# YANKEE ATOMIC ELECTRIC COMPANY

2.C.2.1  
FYR 85-86

Subject: Reactor Coolant Pump Trip - Resolution of Outstanding Items

Figure 1

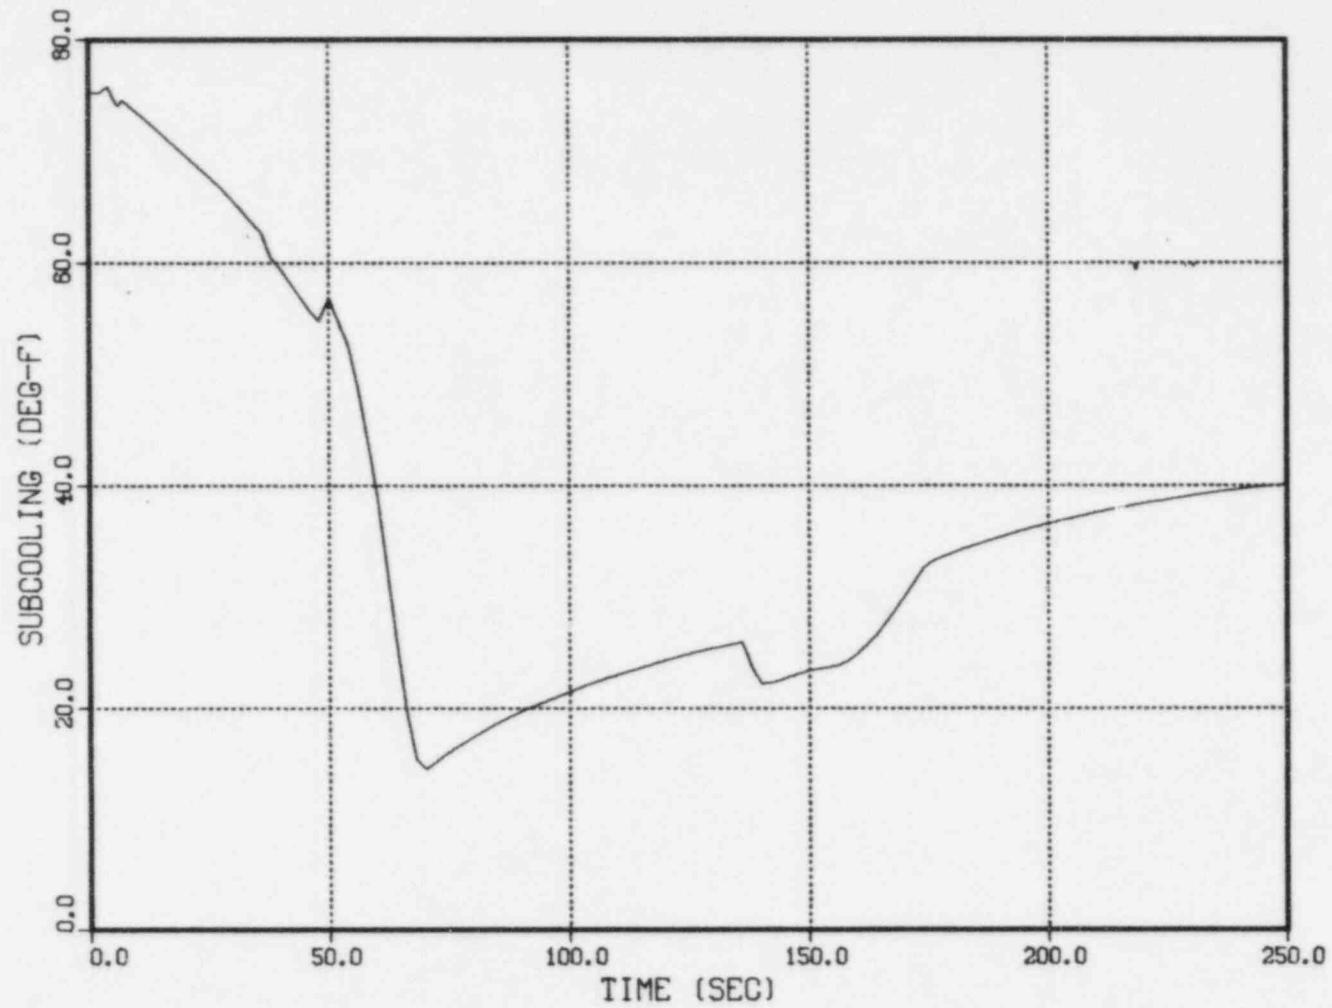
Assure that RCP trip will not occur for Steam Generator Tube Ruptures (SGTRs) up to and including the design basis SGTR.

The design basis SGTR accident with a double-ended guillotine break of one U-tube has been analyzed. The analysis was initiated at 102% power. At the Yankee plant, two pumps are powered on on-site power and two on off-site power. The on-site power pumps were tripped 90 seconds after reactor trip to account for turbine coastdown. The other two pumps were left running throughout the transient. The analysis shows that the subcooling drops to about 18<sup>o</sup>F at about 70 seconds and then increases slowly for the remainder of the transient (Figure 1).

Figure 3

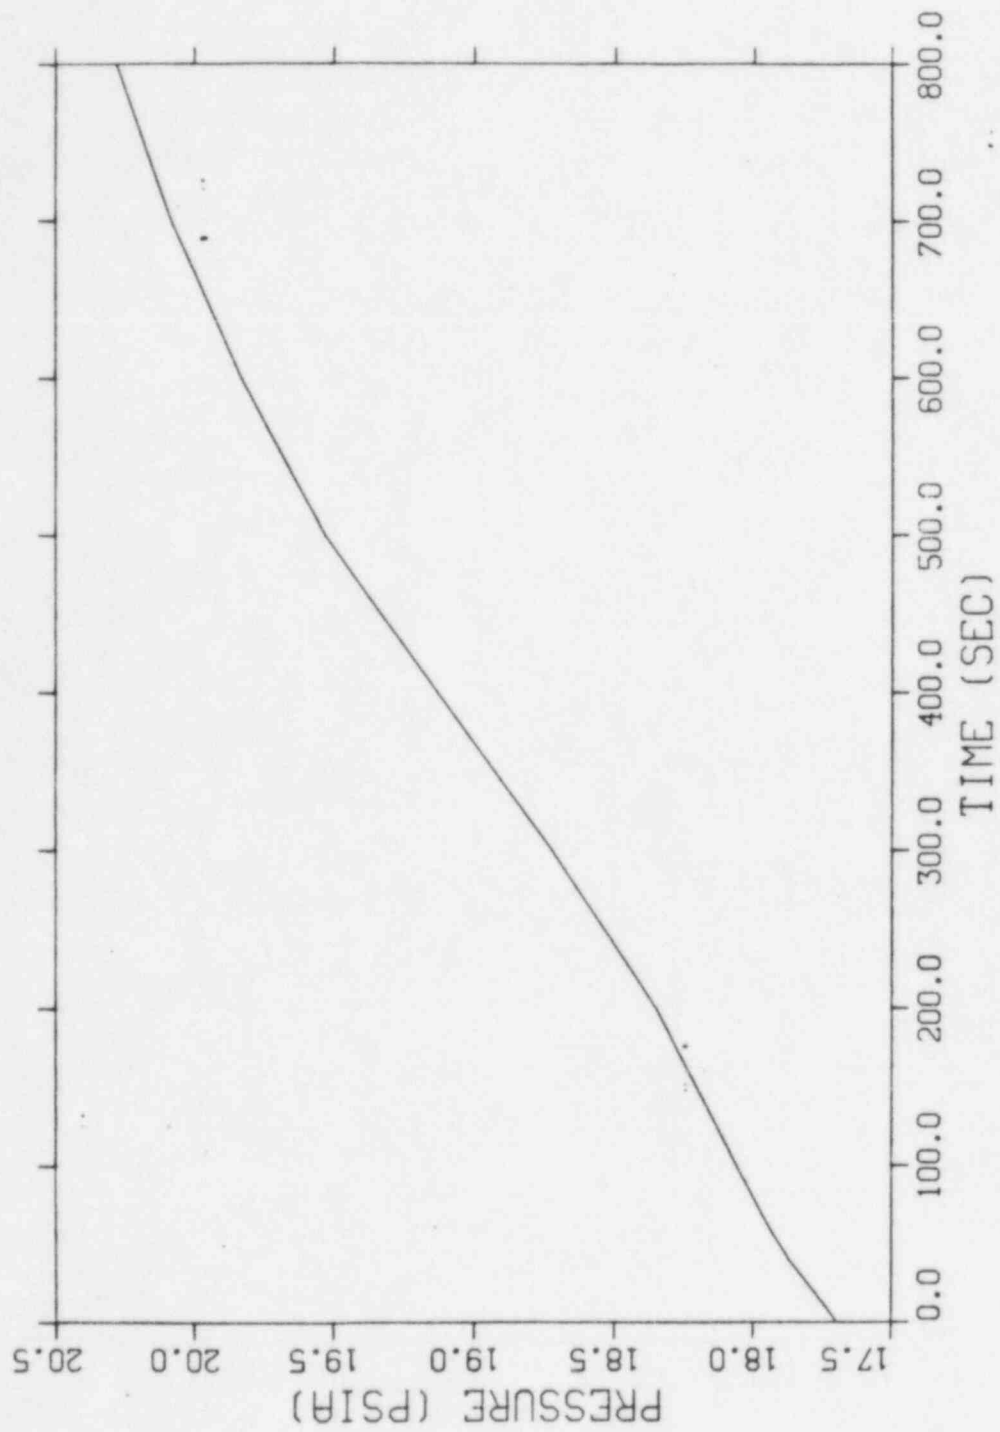
Assure that containment isolation will not cause problems if it occurs for non-LOCA transients and accidents.

A small steam line break inside the containment was postulated. This represents a break in one of the pressure taps in the steam generator dome. The containment pressure calculation for the complete severance of the tap was analyzed with CONTEMPT LT-26. It was found that during this event, the containment overpressure of 5 psig will be reached in 10 minutes (Figure 3). Coupled with the subcooling monitor indication, the operators will know that it is a non-LOCA overcooling transient with containment spill and will proceed accordingly. See response to Question 10 below.

Figure 4

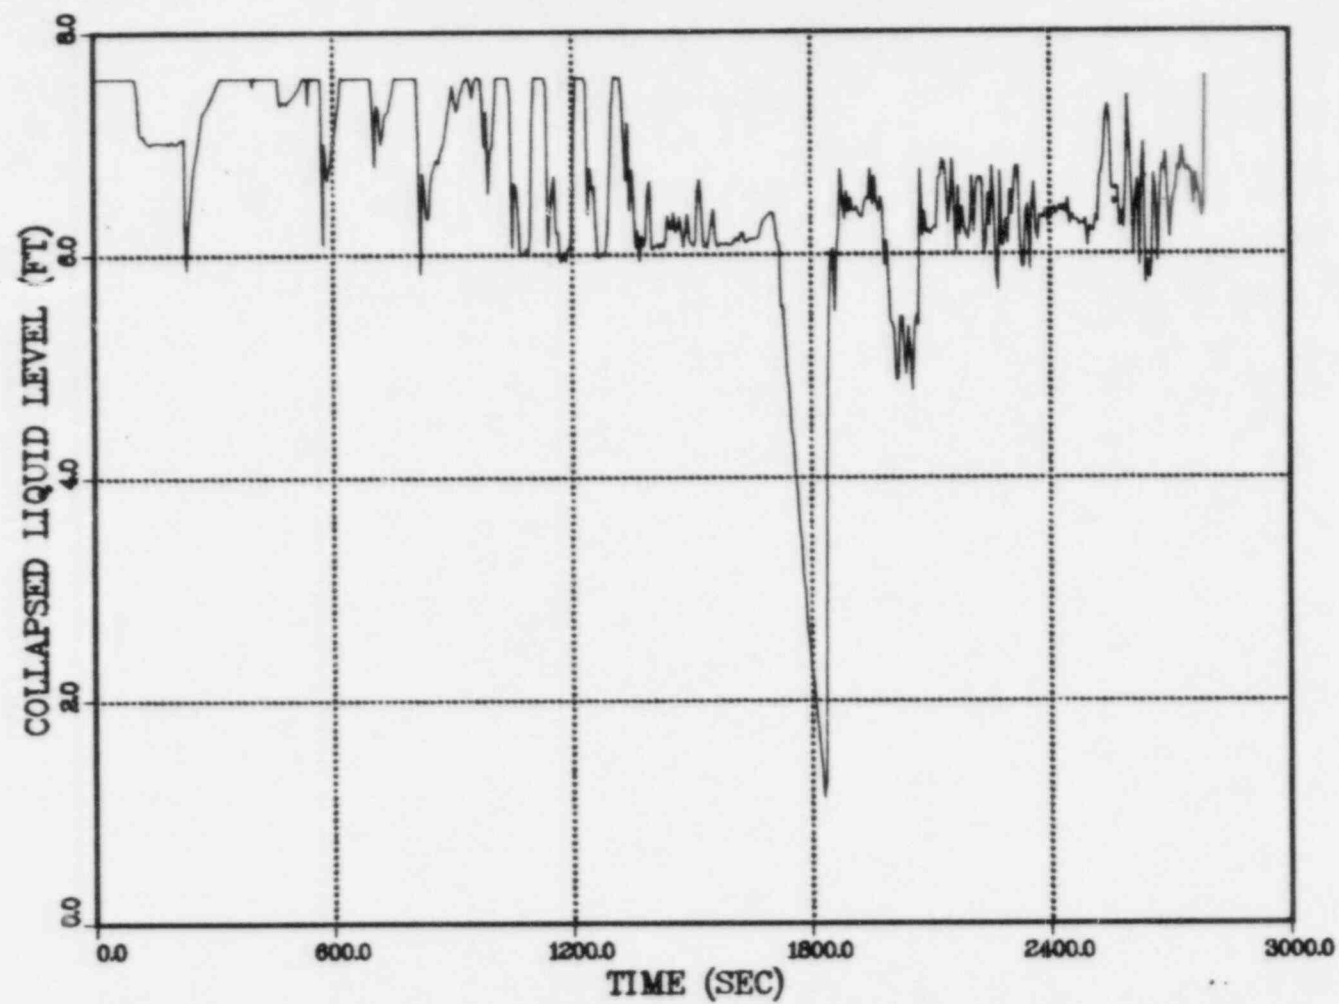
In Figure 3.1.4-4, what is the cause of the large core void spike at 1800 s? The concern is that if this phenomenon is real, how accurately is the resulting temperature spike being predicted in Figure 3.4.1-7?

Case 1BS was used to study the cause of the phenomena observed in these three cases. The sudden drop in core level is seen to occur shortly after 1,800 seconds, as seen in the Case 1BS results (Figure 4). In the vicinity of 1,800 seconds, vessel inventory reaches its minimum, as

In summary, the sudden core level drop in the three cases is caused by a short-term manometer effect which amplifies the effect of increased break flow.
